Model: NAD 30S/30/40 DF67		Date: 31-Oct98	No.: 1
Modified Article: Parts catalog correction		Prepared by: E. Fukuyama	
From: GTS and S Field Information Dept.			
Reason for Modification:	<input checked="" type="checkbox"/> Parts catalog correction	<input type="checkbox"/> Vendor change	<input type="checkbox"/> To meet standards ()
	<input type="checkbox"/> To facilitate assembly	<input type="checkbox"/> To improve reliability	
	<input type="checkbox"/> Part standardization	<input type="checkbox"/> Other

Please correct your parts catalog for DF67.

1. EXTERIOR (A680)

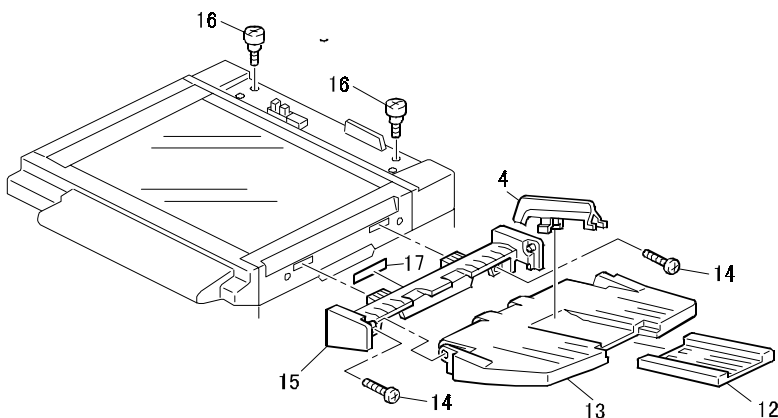
Model: NAD 30S/30/40 DF67		Date: 31-Oct-98	No: 2
Modified Article: Exit Tray		Prepared by: M.Tsuyuki	
From: GTS and S Field Information Dept.			
Reason for Modification:	<input checked="" type="checkbox"/> Parts catalog correction <input type="checkbox"/> Vendor change <input type="checkbox"/> To meet standards <input type="checkbox"/> To facilitate assembly <input type="checkbox"/> To improve reliability () <input type="checkbox"/> Part standardization <input type="checkbox"/> Other

Please correct your ADF parts catalog as follows.

Part number	Old Description	New Description	Page	Old Index	New Index
A6804331	Exit Tray Holder	Exit Tray	5	15	13
A6804321	Exit Tray	Exit Tray Holder	5	13	15

4.ORIGINAL TRANSFER (A680)

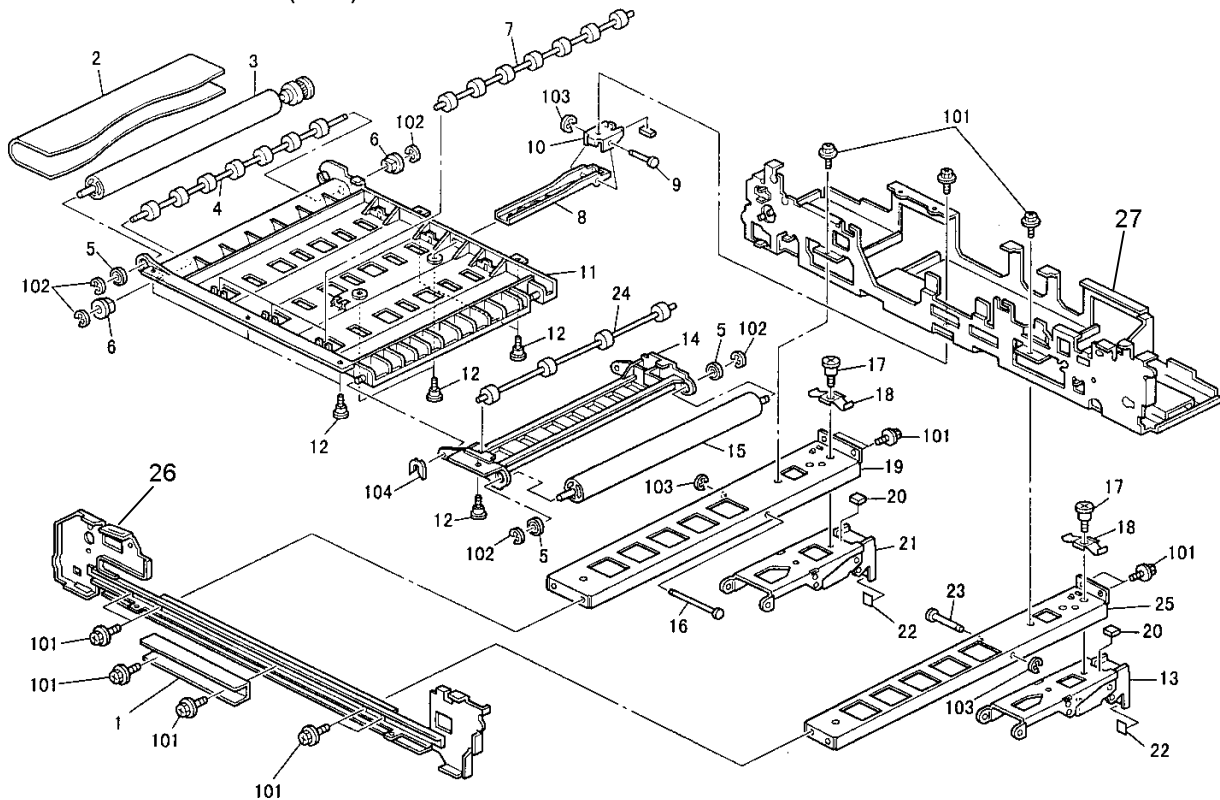
The following parst have been registered as service parts.

New part number	Description	Q'ty	Int	Page	Index
A6801111	Side Plate : Front	0-1	-	11	26
A6801121	Side Plate : Rear	0-1	-	11	27

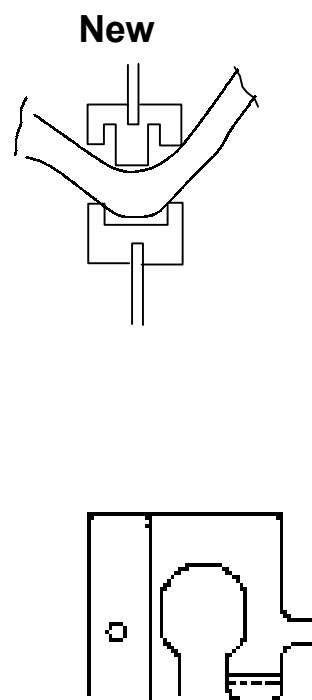
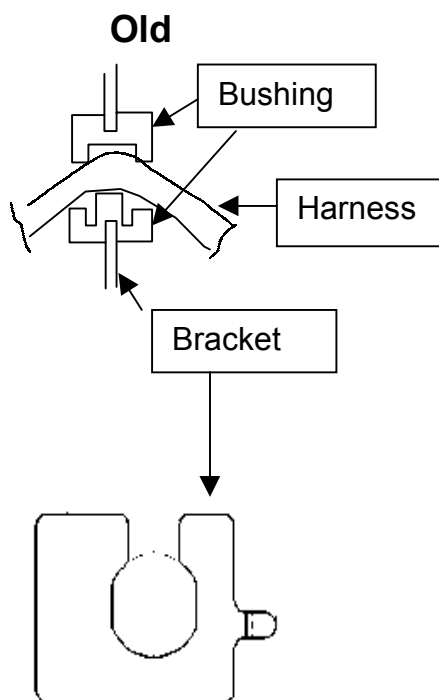
When the DF is opened to full-vertical (90 degrees), stress is applied to the harness in the area of the bushing. This eventually causes a broken connection after this action has been repeated over and over.

The shape of the bushing bracket has been changed to minimize the bending angle of the harness when the DF is opened 90 degrees.

Old part number	New Part number	Description	Q'ty	Page	Index	Note
A6805800	A6805801	Interface Harness	1-1	19	4
